Technical Service Bulletin: tsb100822

Released Date: 07-May-2009

Eliminator™ Centrifuge Service Bushing

Eliminator™ Centrifuge Service Bushing

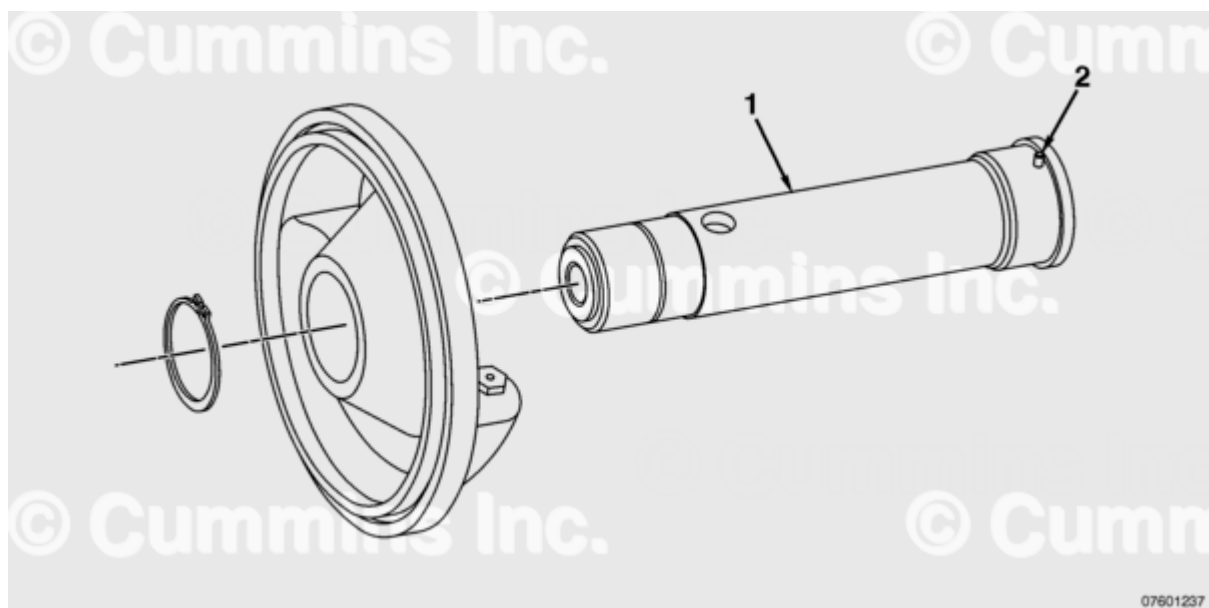
This Technical Service Bulletin provides information on a service bushing for the Eliminator™ centrifuge. The service bushing, Part Number 3640564, can be used on QSK38/45/50/60/78 and KV38/50 engines. It can **not** be used on the QSK19 or K19 engines or on Fleetguard® centrifuges.

Excessive sludge or improper alignment can cause the bushing to become out of round. Be sure to clean the entire disk stack if there is excessive sludge in the centrifuge, to prevent future damage.
